Motorized Stage Update

Rotary Stage $\phi 39 / \phi 59$: KRW04/KRW06

Specification changes/Improvements

① Additional connector option

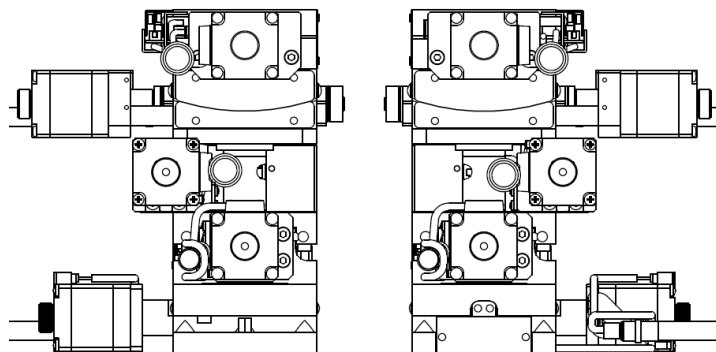
New model

KRW04 Pigtail

KRW04 Panel Mount

KRW06 Pigtail

KRW06 Panel Mount
